Subject: AP1000 Response to Request for Additional Information (TR 44)

# AP1000 TECHNICAL REPORT REVIEW

RAI Response Number: RAI-TR44-016

RAI Response Number: RAI-TR44-017  
Revision: 2

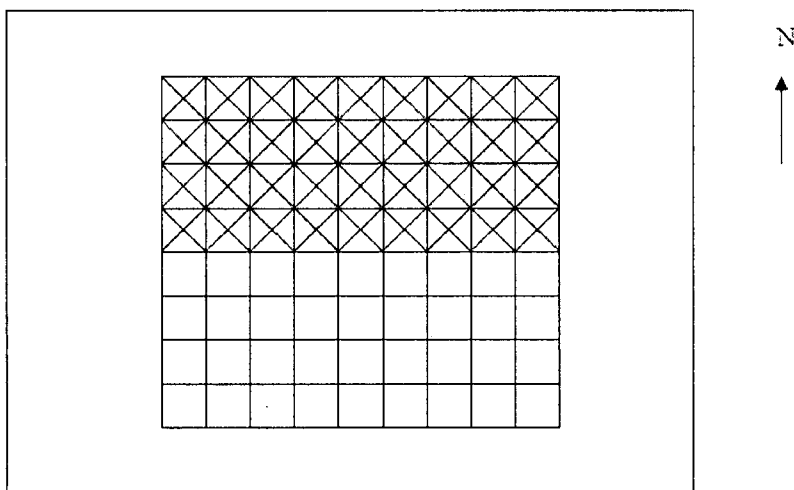
Explain whether only a full fuel rack is considered in the simulation, or if several scenarios are considered; i. e., different fill ratios, from empty to full. Provide the technical justification if only a full rack is considered.

Following the August 2009 audit with the NRC, Westinghouse has completed an additional run (Run Number 4) to examine the effects of the worst possible partial rack loading scenario (half full, all on one side, as depicted in the following figure). The results of this additional run will be included in Revision 2 of TR-44. Also, DCD Section 9.1.1.2.1, Item A, is modified to indicate that a partially filled loading case was evaluated.

Replace DCD Figure 9.1-1 with the following figure:

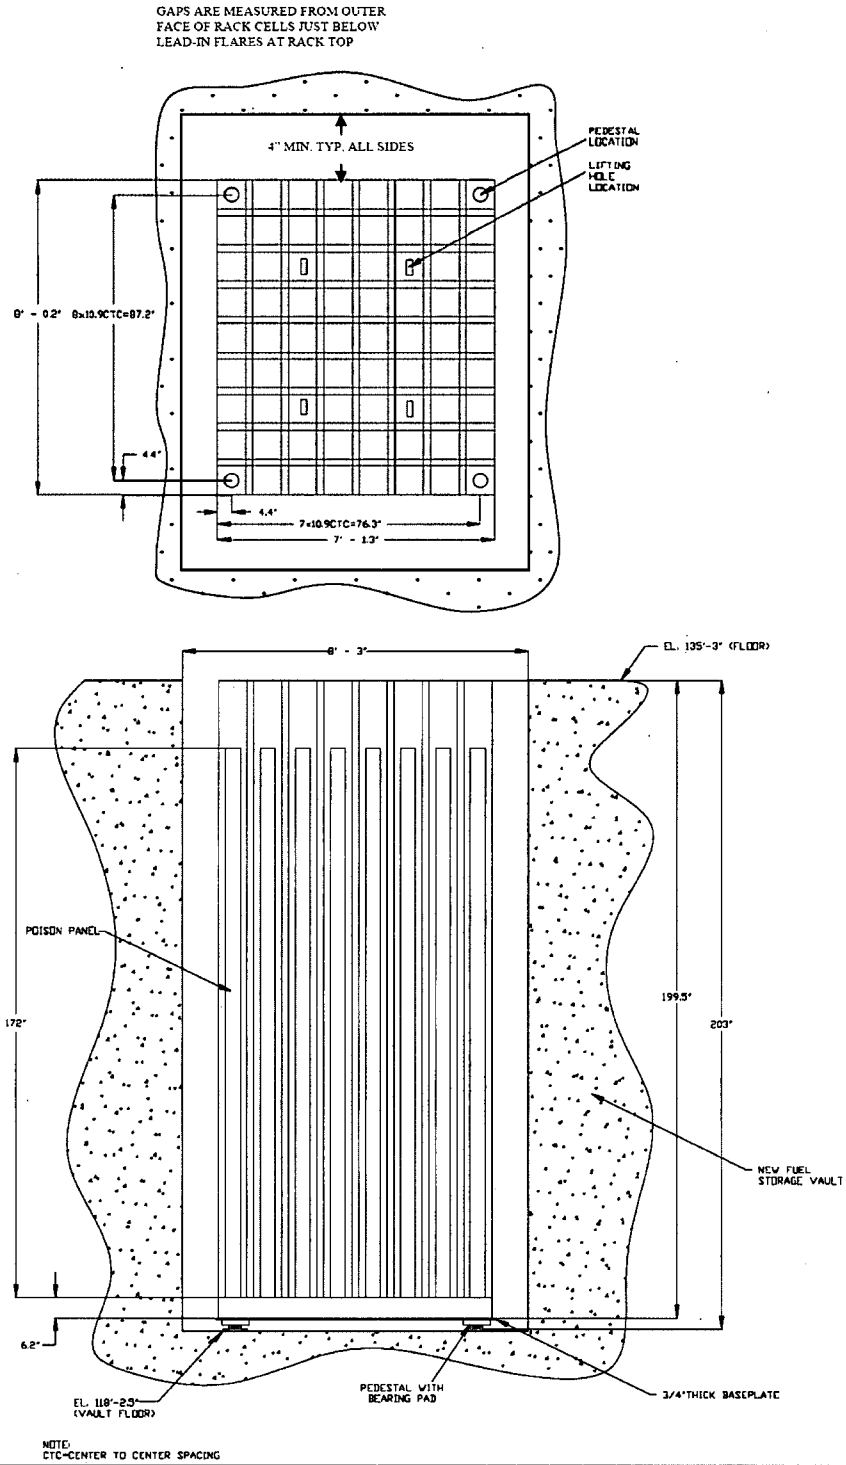
What are the gaps and tolerances for each of the gaps between the fuel assembly and cell wall, and between the rack and vault wall? What are the assumed initial locations of the various components (fuel assemblies and rack) and what is the technical basis for this assumption. Were any studies done for different initial conditions (considering tolerances); if not, explain why it was not necessary. Are there requirements in the DCD to ensure that the assumed gaps (considering tolerances) are maintained throughout the operating license period?

Following the August 2009 audit, Westinghouse is updating DCD Figure 9.1-1 to include additional details related to the placement of the New Fuel Storage Rack within the New Fuel Pit. Figure 9.1-1 will be updated as shown in the DCD Revision section below to show the general position of the rack within the pit, including a definition of the minimum gaps. The only changes to the figure are that the rack is now shown within the vault and the 4 inch minimum typical gap dimension along with the clarifying note about where the gaps are measured from have been added. The 4 inch minimum gap is conservative based on the maximum rack displacement of 3.2 inches (which occurs at the top of the rack; the maximum displacement at the baseplate elevation is only 0.5 inches) when the 0.2 COF is ignored (justification for ignoring the 0.2 COF case is discussed in the response to RAI-SRP9.1.2-SEB1-02, Revision 1).
